From: Johnson, Roy
Sent: Wednesday, February 27, 2002 10:56 AM
To: 'bill.ordemann@el Paso.com'; Catanach, David
Cc: 'james.duckworth@el Paso.com'; Wrotenbery, Lori
Subject: Well No. VPR 'E' 34 and Administrative Order SWD-826

APPLICATION FOR AUTHORIZATION TO INJECT

El Paso Energy Raton, L.L.C.
 Vermejo Park Ranch "E", Well #34 Water Disposal
 1268.5' FNL & 368.2' FEL
 Section 5, T31N, 19E
 Colfax County, New Mexico

WELLBORE SCHEMATIC

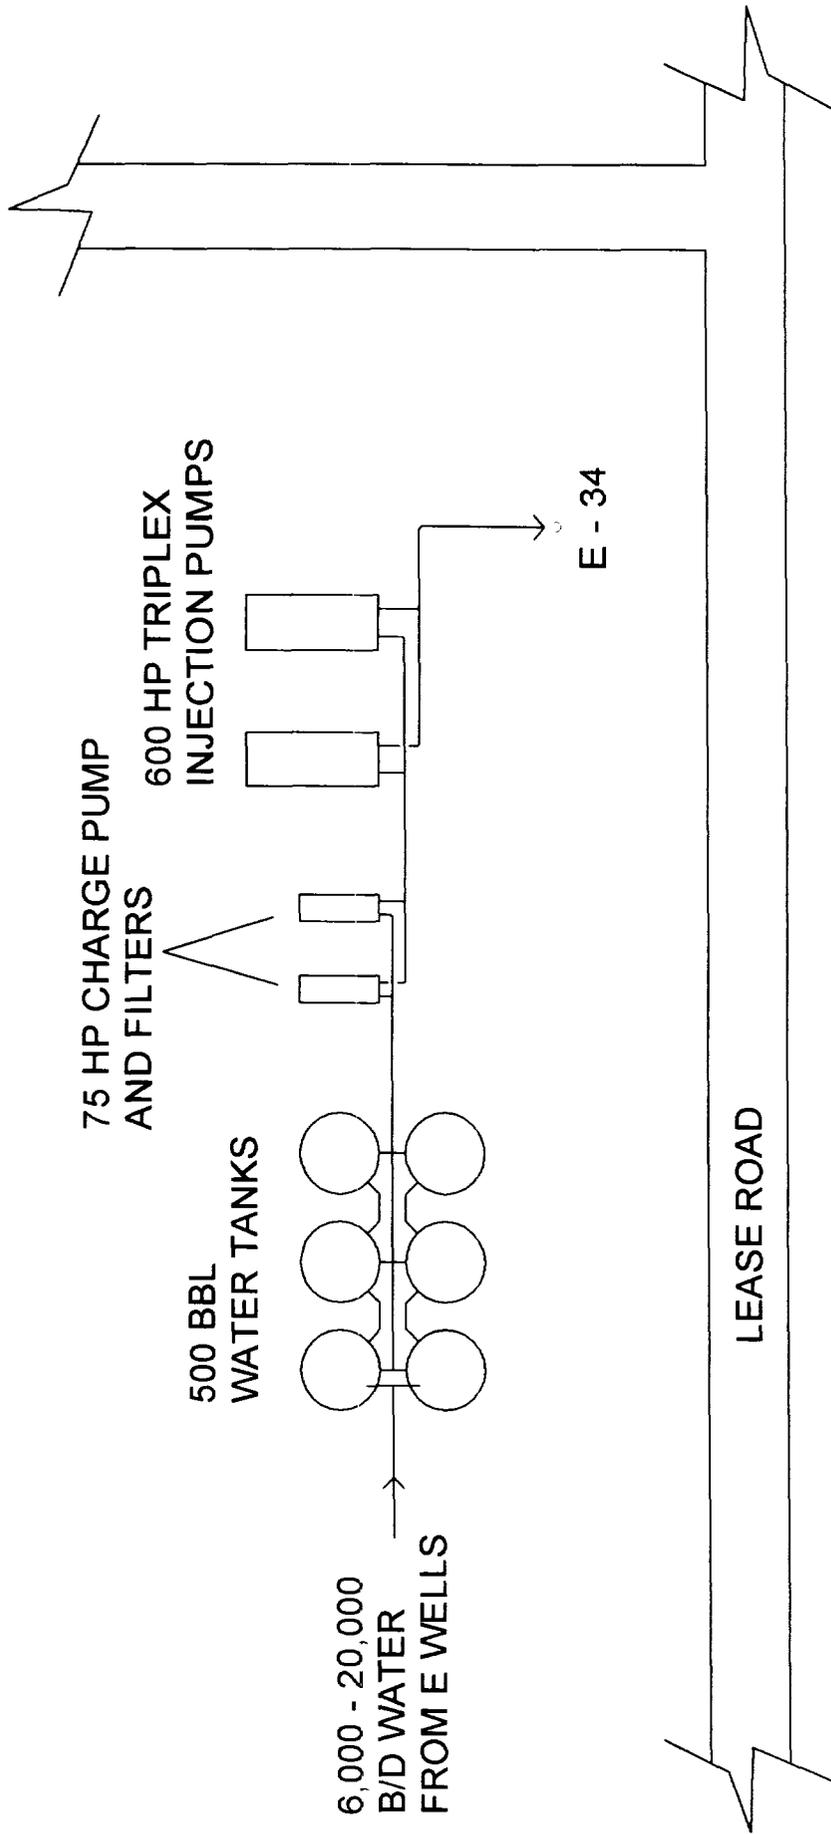
As we discussed on Monday night this office will require additional information on the subject well prior to any injection. The amended application for injection needs to address the changes in well bore construction and the formations that are to be injected into. In light of the fact that this well has encountered so much gas in formations below the Trinidad Sandstone and that Devon has a 100% interest in these formations this office will require a waiver from Devon that states they have no objection to the disposal of produced water into this well bore. There also may be an issue that Vermejo Park Ranch may require notification and you may want to review this with your legal staff.
